PA 05430/02: Re-location of a kerb-side pump and the change of use of part of existing plant yard into a fuel filling station, works include demolition of existing rooms and their re- location , landscaping of site, cleaning, upgrading of existing yard and to sanction, Site at, Tal-Blata I-Għolja, Mosta.

4 EPD COMMENTS AND CONCLUSIONS

Figure 1: Surface water flow on site and surrounding area

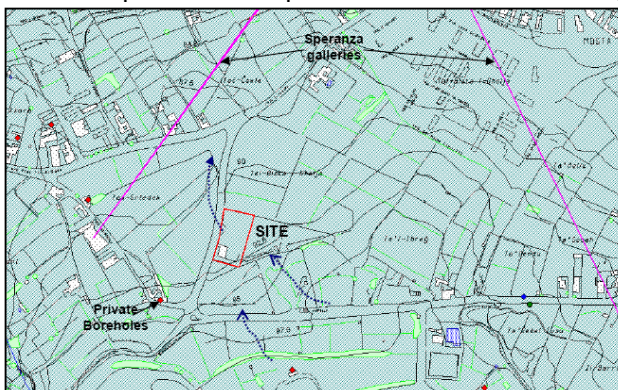
It is being noted that rainwater reservoirs will be used on site. Plans indicating the location of these reservoirs together with their capacity are required.

Also the location of the gutter system through which storm water will be diverted towards a separator should ideally be shown on the block plan. The management of storm water is an extremely important issue in the area particularly due to the Speranza galleries that are located in the vicinity. As the map indicates hereunder is directed towards Wied Speranza.

The MRA draws your attention to the fact that there are a number of private boreholes on site, as confirmed in the appendices (report by Saviour Vella, p.4) which are known to be used for irrigation purposes. Moreover contamination plumes are known to travel and are not stable, thus implying that agricultural land and water resources per se will be put at considerable risk. In light of this severe mitigation measures are required.
